BAR #2019-00042 & 00043

ISSUE: Appeal of a decision of the Board of Architectural Review approving a Permit to Demolish (partial) and a Certificate of Appropriateness for an addition, alterations and a Waiver of the Rooftop Mechanical Screening Requirement in the Old & Historic Alexandria District

LOCATION: 405 South Fairfax Street

BAR #2019-00042 & BAR #2019-00043
405 South Fairfax Street

Figure 1: Private alleys shown in yellow. Addition footprint shown in red.

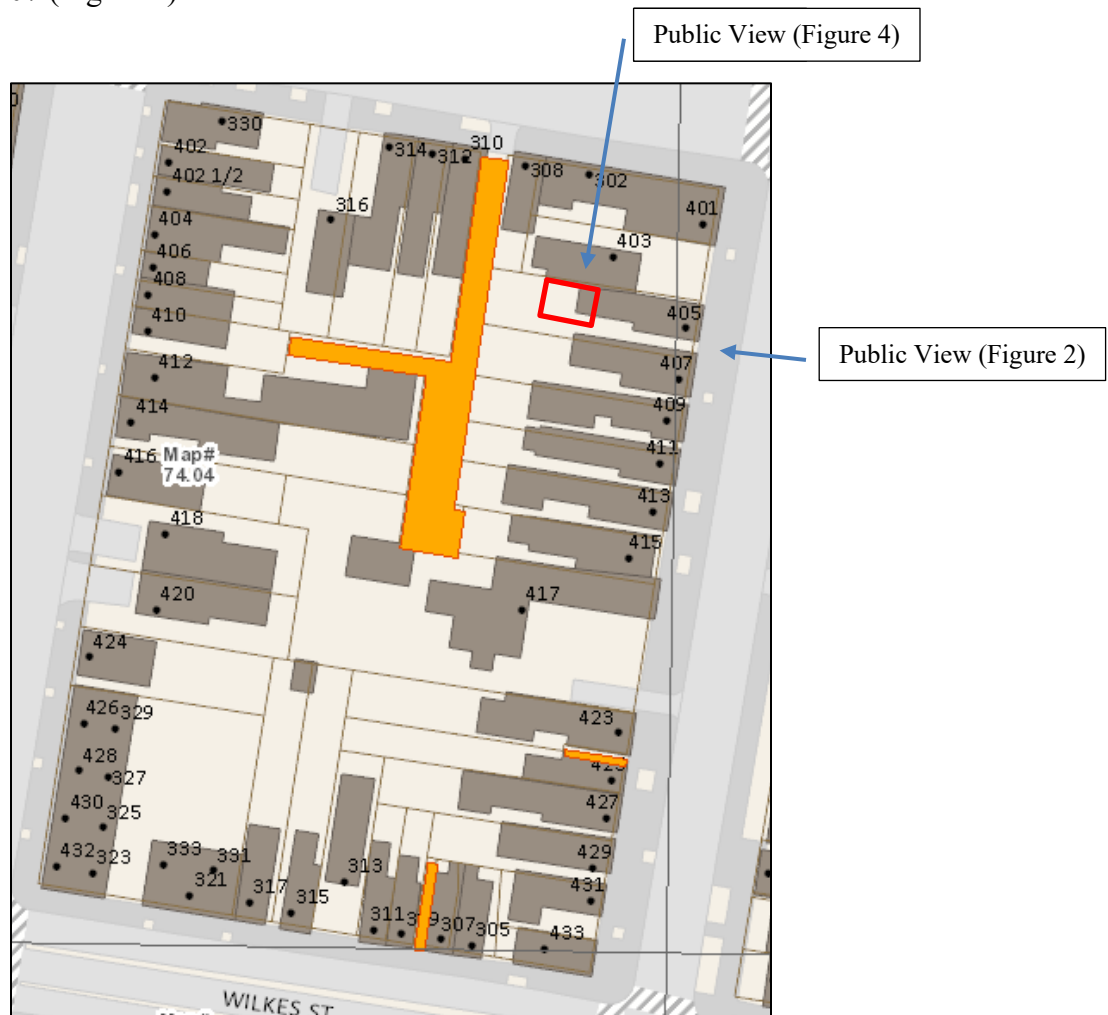
In the present case, the alley behind the subject property is private (Figure 1), so the visibility of the proposed addition is limited to what can be seen through a narrow aperture from South Fairfax Street and over intervening roofs from Wolfe Street. Today, only a small portion of the existing rear ell is visible from South Fairfax Street between the five-and-a-half foot break between 405 and 407 (Figure 2).

Figure 3: Approximate portion of the east elevation of the addition which will be visible to the public from South Fairfax Street outlined in red

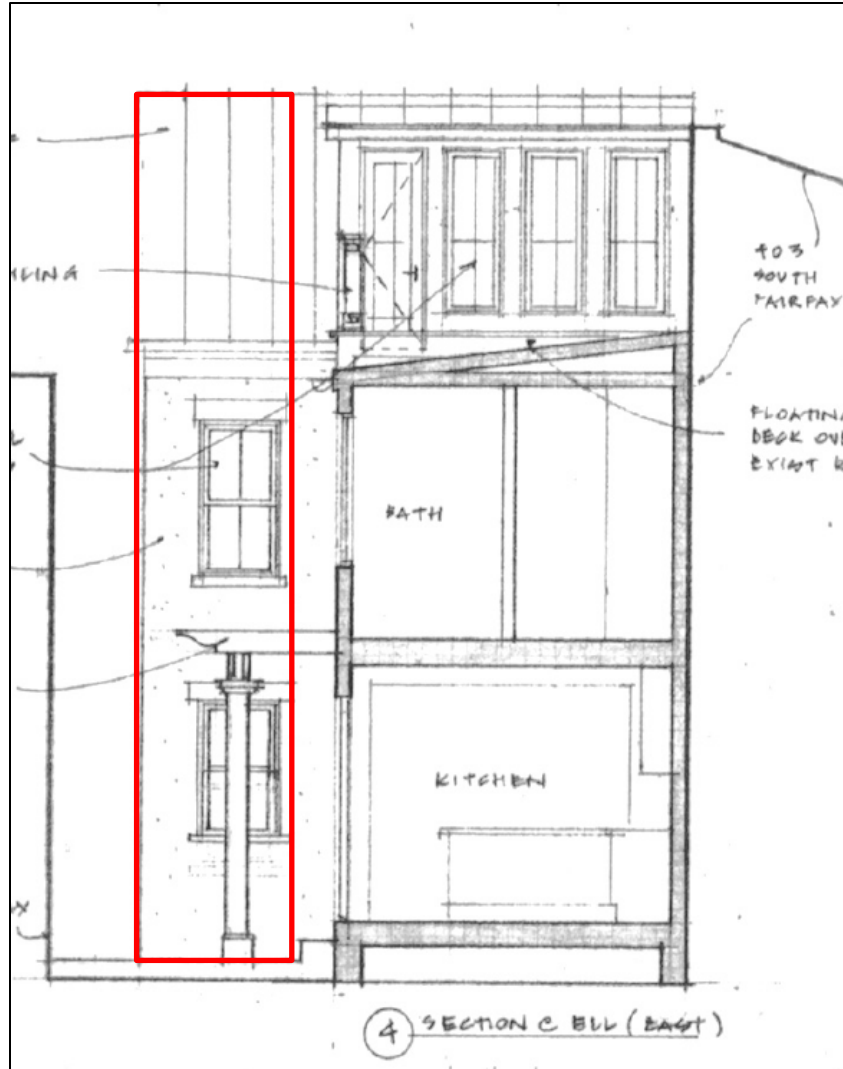
Because the proposed addition will be roughly two-and-a-half feet wider than the existing frame ell, and taller, the new addition will be slightly more visible from South Fairfax Street than the current ell (Figure 2), though the visible portion will be located approximately 50 feet from the front property line (Figure 3).

Figure 1: Areas of proposed demolition

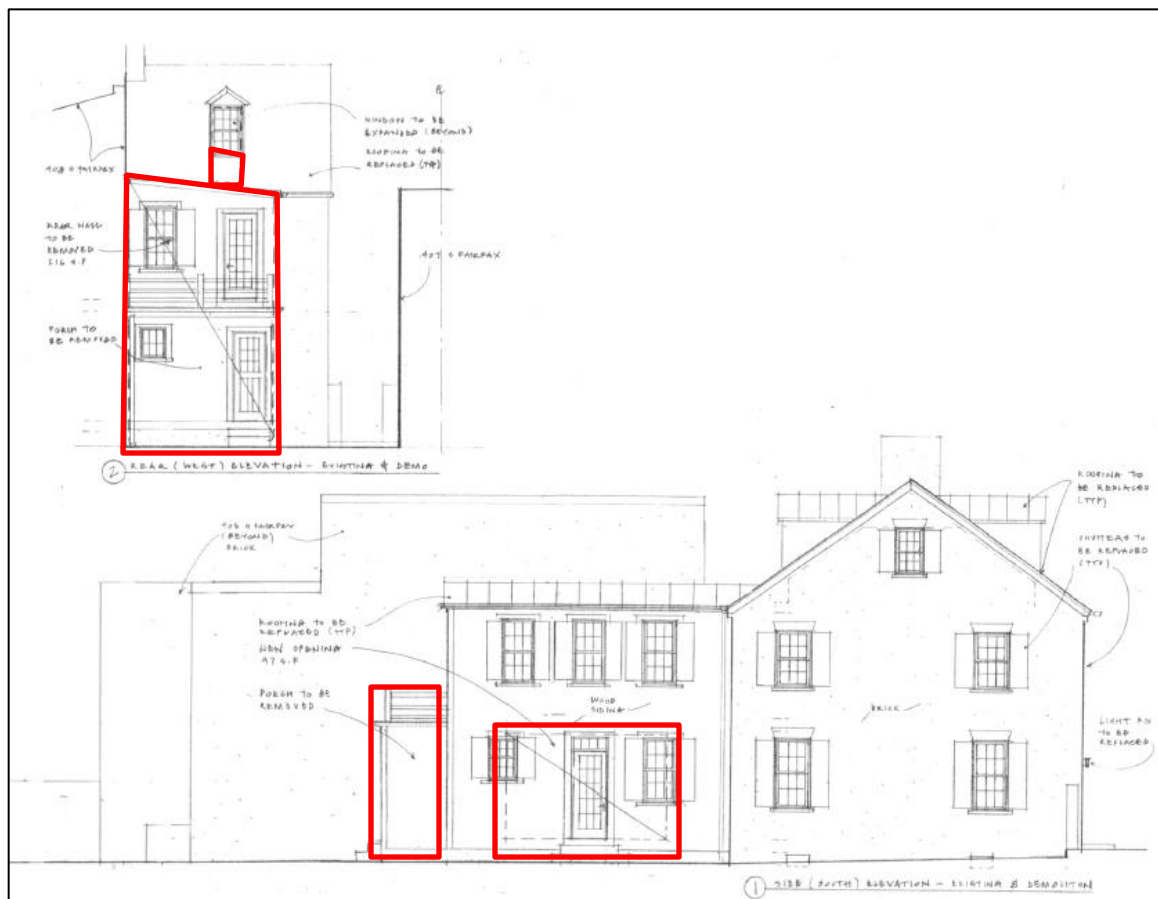
The following features will be demolished to make way for the new construction and alterations (Figure 1):

- Demolish the area under the existing dormer window on the rear roof slope (4.5 square feet)
- Demolish a 13 foot by 8 foot portion of the first-floor south wall of the two-story frame ell (97 linear square feet)
- Demolish the one-story rear frame addition (72 square feet)
- Demolish the second-floor rear elevation of the ell (216 linear square feet)

The amount of demolition on the historic main block is limited to a 2 foot by 2.25-foot area of the rear roof slope, which is not visible from a public way and on its own would not require approval of a Permit to Demolish. On the frame ell an area measuring approximately 100 linear feet, including two windows and a door, will be demolished as will the mid-20th century one story addition and balcony railing and the second floor rear wall. Only a small portion of the existing frame features are visible from South Fairfax Street (Figure 7). Staff has visited the site on more than one occasion to view interior trim and exposed framing to confirm the construction chronology. While the interior framing materials confirm the early 20th construction of the ell, the exterior siding and windows suggest later alterations. The applicant originally suggested the full demolition of the rear ell but worked with staff to find a solution that preserved most of the south façade and the form and framing of the second period, early 20th century ell.

None of the features that will be demolished exhibit a high level of design or architectural detail and they could be reproduced easily. Staff does not find that the proposed demolition compromises the overall integrity of this historic townhouse nor will the demolition negatively impact nearby buildings of historic merit. In the opinion of Staff, none of the criteria are met and the Permit to Demolish for this limited amount of material should be granted.

Figure 6: Map showing private alley to the rear of 405 South Fairfax Street

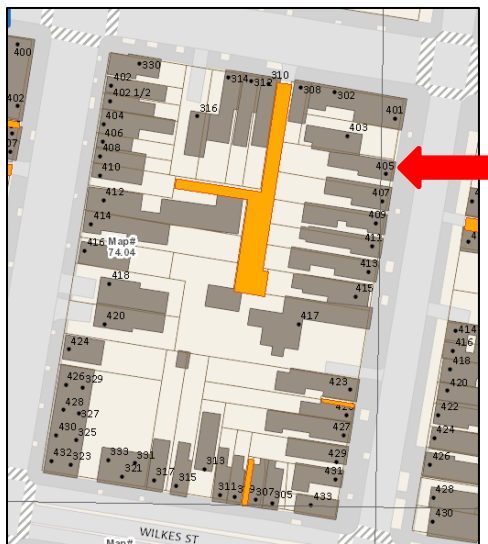
The alley to the west, behind the subject property, is private (Figure 6).

Figure 8: Visibility of deck railing and addition from the right-of-way

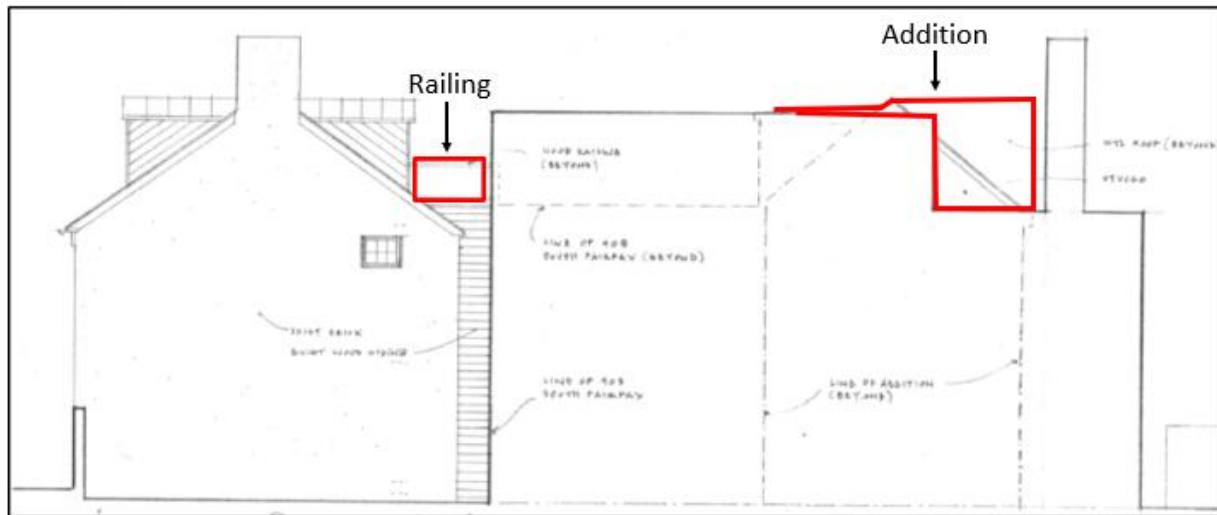
The BAR regularly approves rear additions that are visible from a public way, which is why the *Guidelines* encourage new features to be contextual, compatible and of quality design, while being subtly differentiated from the historic portions. In the opinion of staff, the applicant has achieved this differentiation through the use of different fenestration (two-over-two windows), materials (stucco) and roof form. The addition is also located on a different plane than the historic building or ell – it projects farther into the side yard but will be set back three feet from the adjacent house and fence, though technically six feet from the lot line (three feet of the neighbor's house and garden are located on the lot belonging to 405 South Fairfax Street). The addition in its entirety will not be visible from a public way. Only a small portion of the east elevation of the new addition will be visible from the 5.5-foot walkway between 405 and 407 South Fairfax Street. The railing of the roof deck and a portion of the third floor of the addition will also be visible from the right-of-way, as shown in Figure 8. The railing will only be seen at an oblique angle due to the house on the corner of Wolfe and South Fairfax Street. A portion of the top floor of the addition will be visible from Wolfe Street as shown in the photo in Figure 9.

Figure 710: Aerial of subject block showing proposed addition footprint

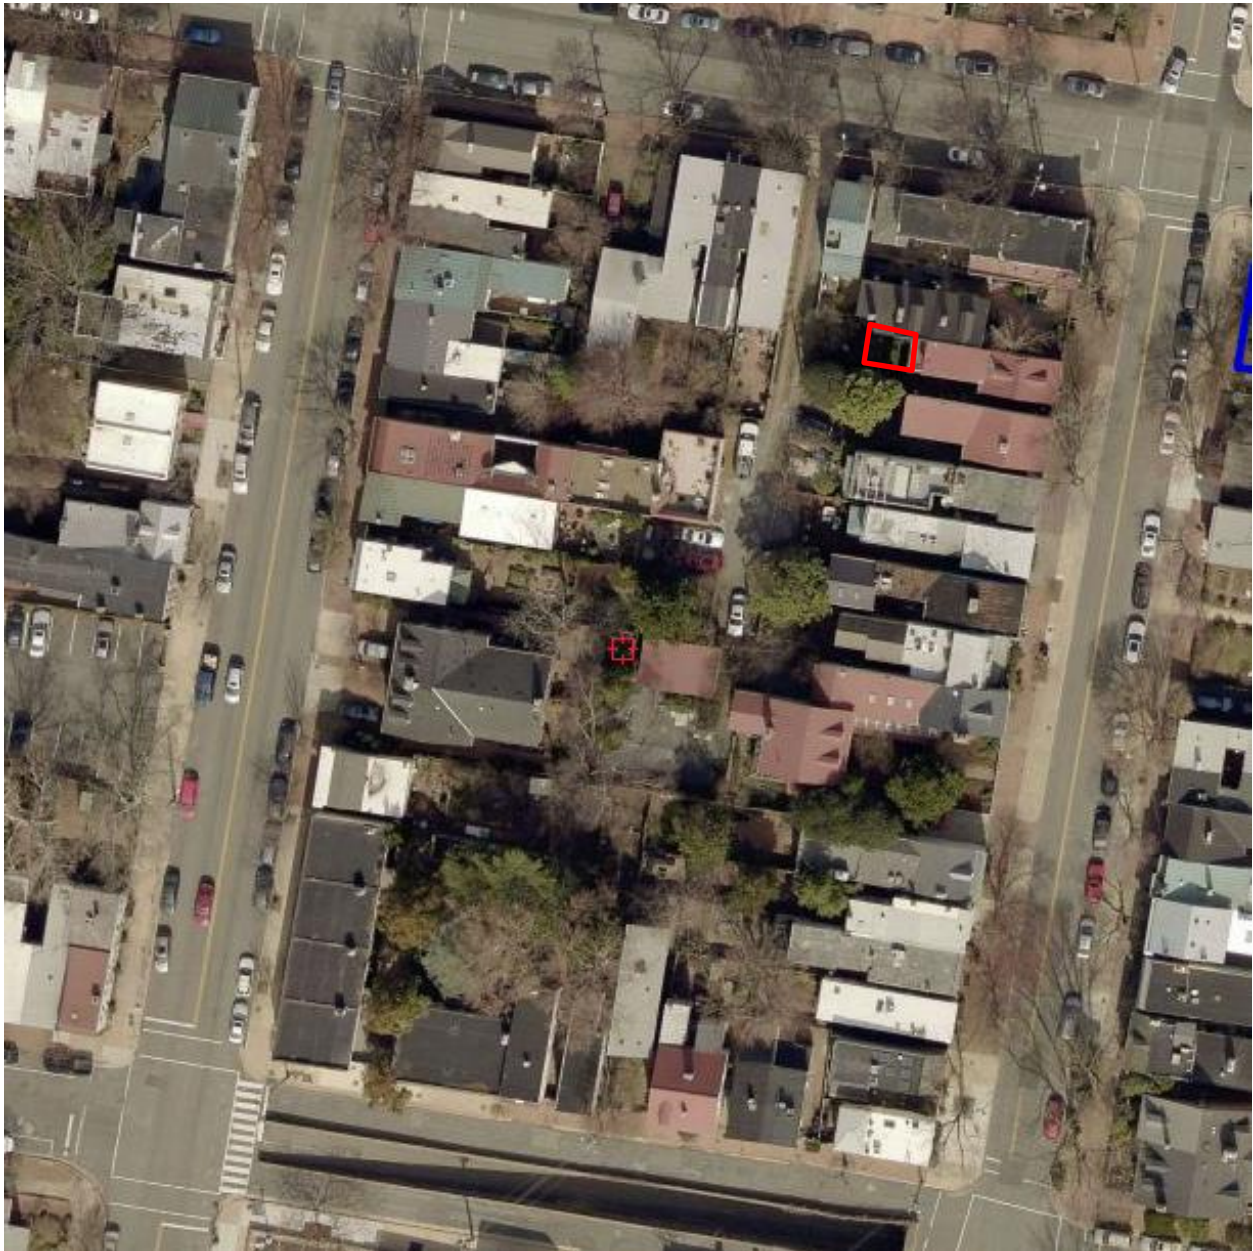
While staff would prefer a more diminutive addition that does not utilize an attic floor, the applicant strongly desires this additional space and access to a new roof deck. With existing large additions to the north and south of the rear yard, shown in photos the application materials, staff believes the proposed addition will have minimal impact on its immediate neighbors. In comparison to many mid-block additions that the BAR approves, the proposed addition is among the least visible from the right-of-way and staff is in support. As the image below shows (Figure 10), the block where 405 South Fairfax Street is located is quite dense with a variety of building footprints equal to and larger in size. As discussed by the BAR at the previous meeting the context of an addition is more important than its absolute size.

Despite its size, the proposed addition has very little impact on the historic fabric or the original house or additions constructed during the architectural period of significance of the OHAD (1749-1934). It is well designed and compatible with the historic main block yet subtly differentiated in design to suggest its later construction. Although the applicant specifies traditional building materials such as wood, stucco and metal, in recent years the BAR has supported the use of modern and synthetic materials on new construction and staff would have no objection to the use of modern materials in this location that otherwise comply with the BAR's policies.
